**AGENDA**  
**BEAUFORT COUNTY DESIGN REVIEW BOARD**

**Crystal Lake Park – Observation Tower**

**Type of Submission:** Final  
**Applicant:** Beaufort County  
**Project Architect:** Rob Montgomery, Montgomery Architecture and Planning, Inc.  
**Type of Project:** Public Park  
**Location:** Located at the intersection of Lady’s Island Drive (US 21) and Rue Du Bois  
**Zoning Designation:** T1 – Natural Preserve  
**Project Information:** The applicant is proposing to construct an 83 foot tower in Crystal Lake Park on Lady’s Island. The tower will be timber construction and sided with pressure treated lumber. The Design Review Board is being asked to look only at the tower. The site and landscaping plan were previously approved by the Corridor Review Board.

Tower Section & Elevation  
Crystal Lake Park  
Lady's Island Drive  
Lady's Island, SC

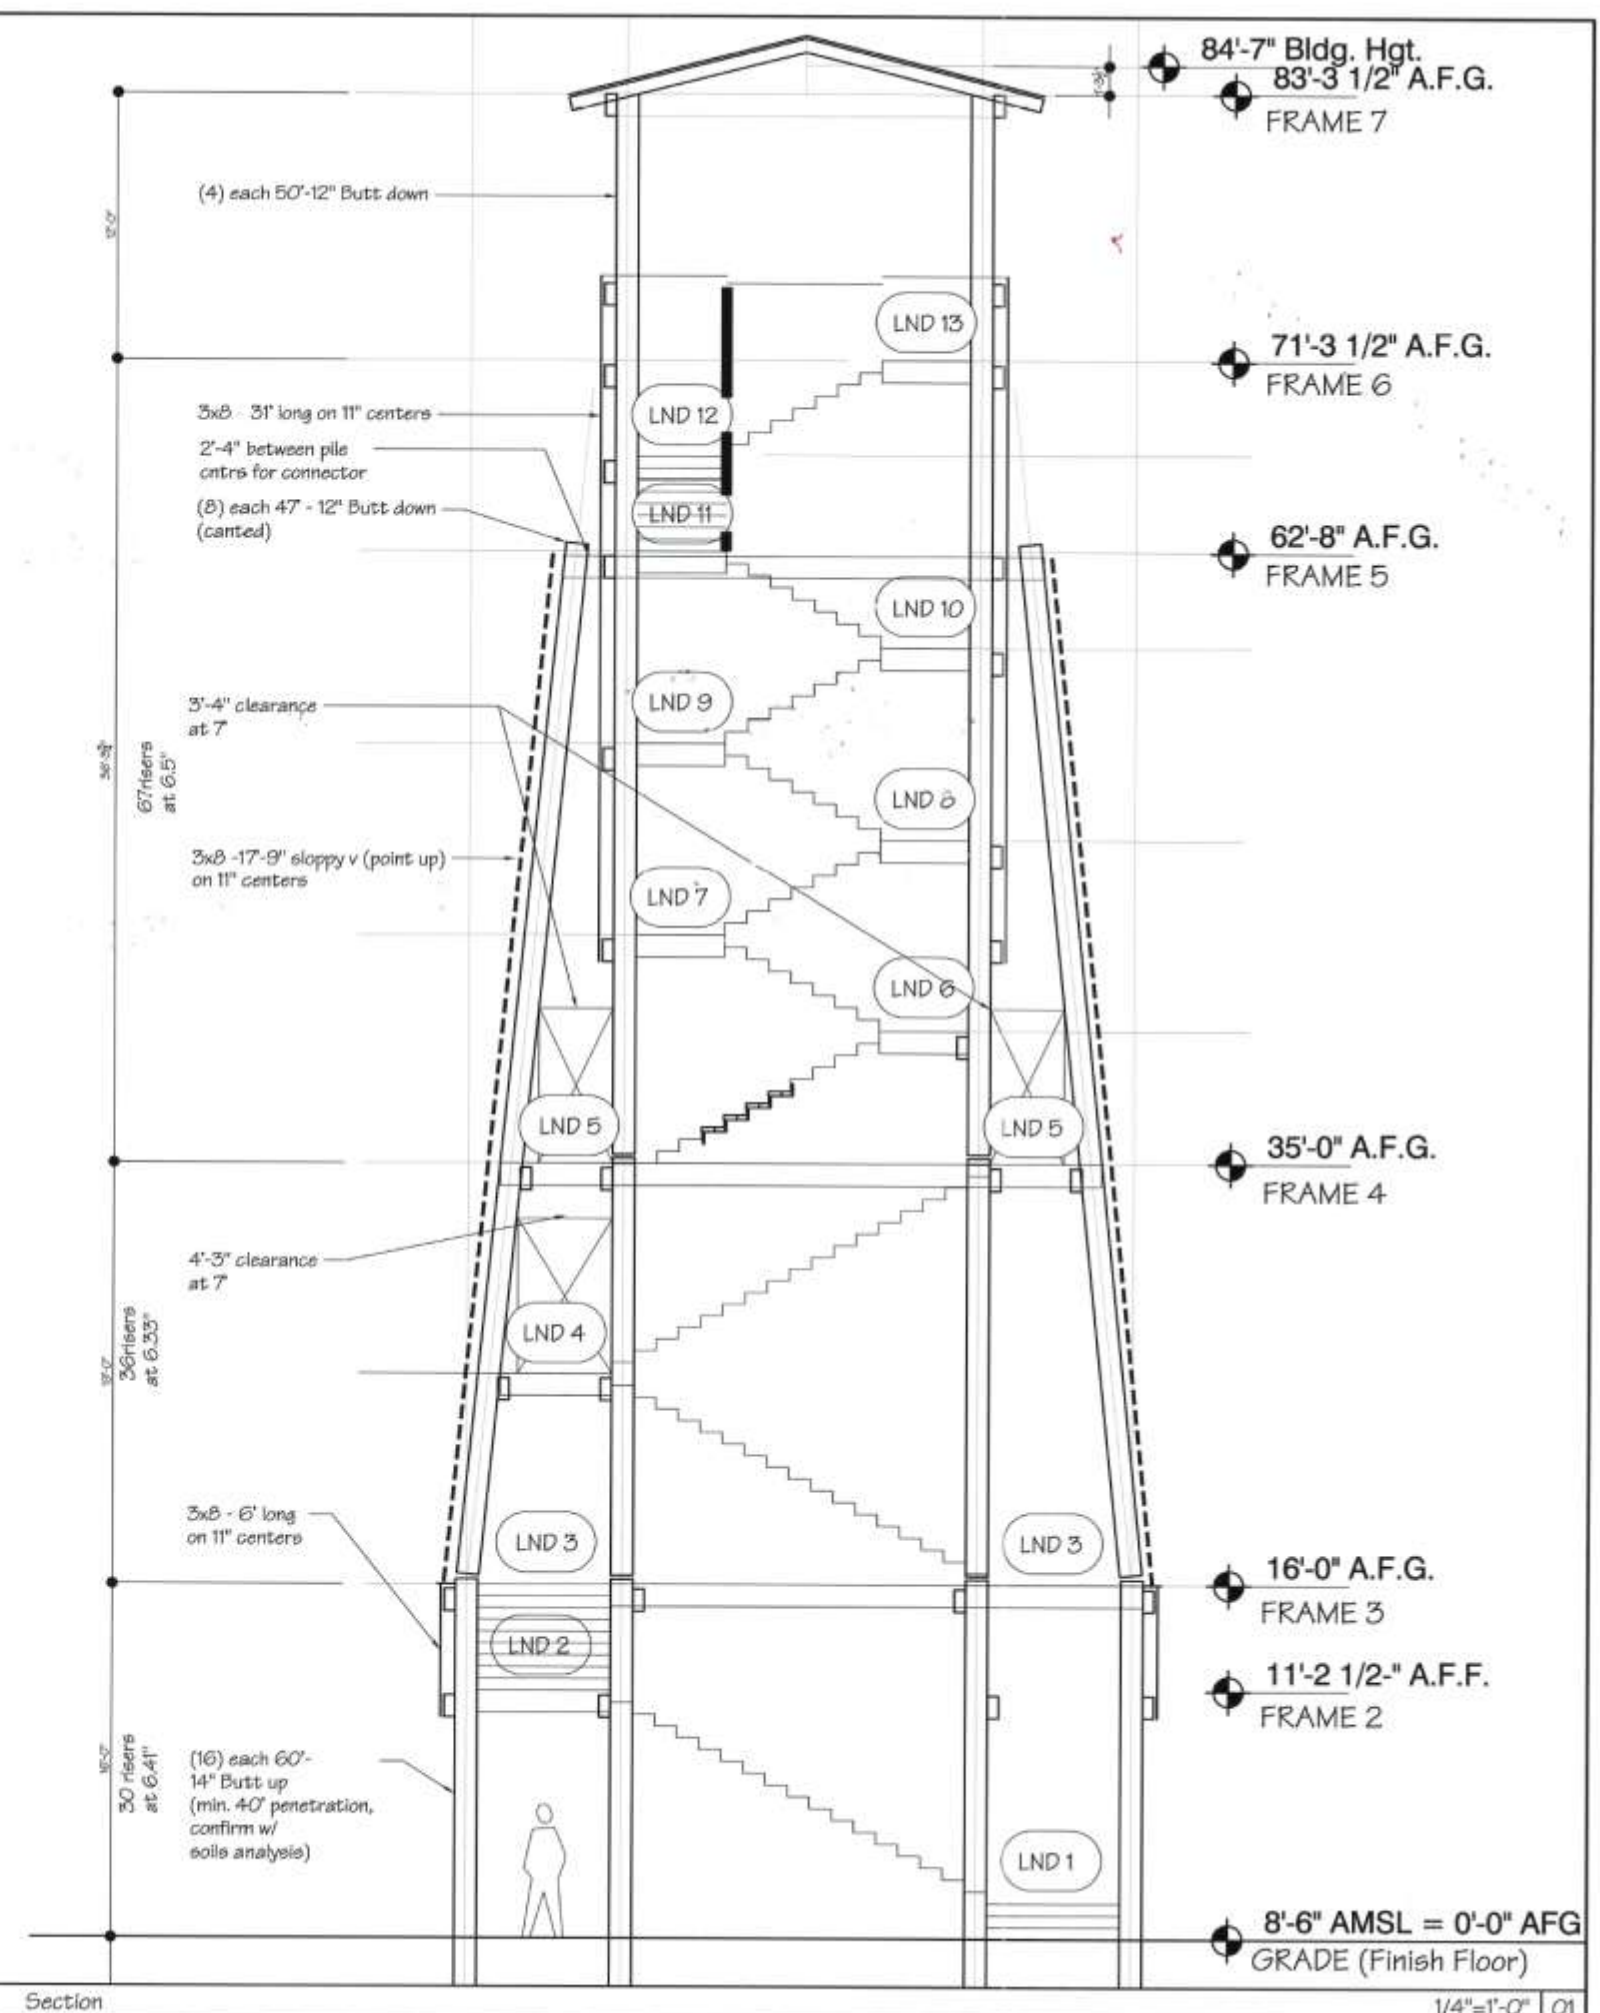
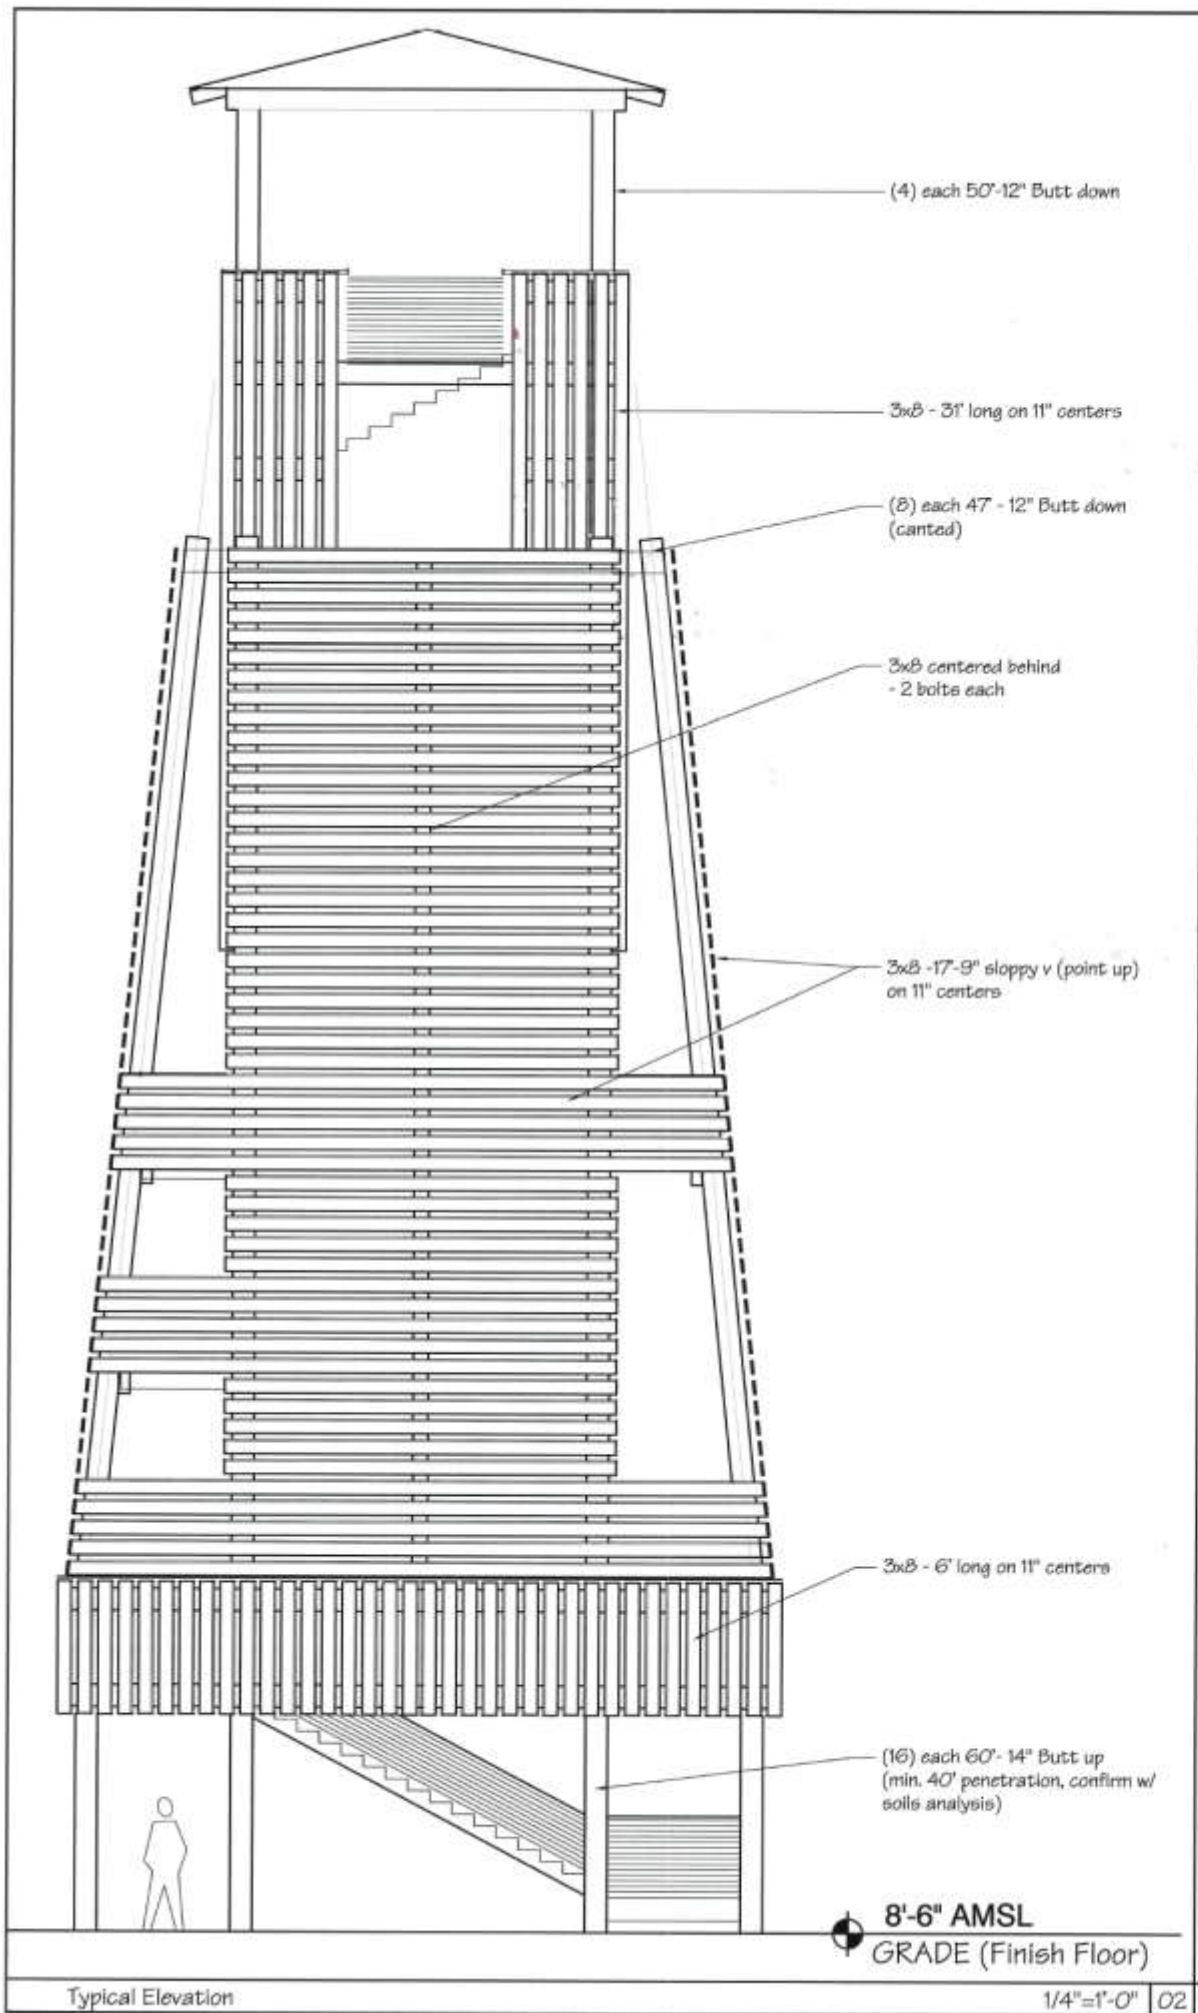
**Staff Comments:** The project meets the applicable architectural standards of Section 5.3.30 of the Community Development Code with the exception of the requirement that new buildings are compatible with surrounding buildings and the minimum roof pitch of 4:12. The proposed project is a landmark building and therefore by its very nature is meant to be singular and stand out.

<b>Entrances:</b> The main entrance to a building shall be clearly identifiable and shall be oriented to face a street, internal drive aisle, plaza or pedestrian way. Entrances shall incorporate design features such as canopies, porticos, arcades, raised cornice parapets or peaked roof forms over the doorways, arches, and display windows.	n/a
<b>Vertical Articulation:</b> Buildings shall incorporate such elements as wainscoting, water tables, canopies, rooflines and parapets to provide vertical articulation. For multi-story buildings, the building elevations shall clearly reflect a bottom (first) floor and its representative interior height, a middle ground consisting of all floors above the first floor and a visually pronounced building top that consists of a defined cornice at the top of the parapet roof section or at the transition of the sloped roof section.	meets standard
<b>Pitched Roofs:</b> Pitched roofs are encouraged for all buildings with a footprint of 15,000 square feet or less. Where pitched roofs are utilized, the minimum pitch shall be 4:12 and overhanging eaves shall be incorporated into the design of the building.	see comment below
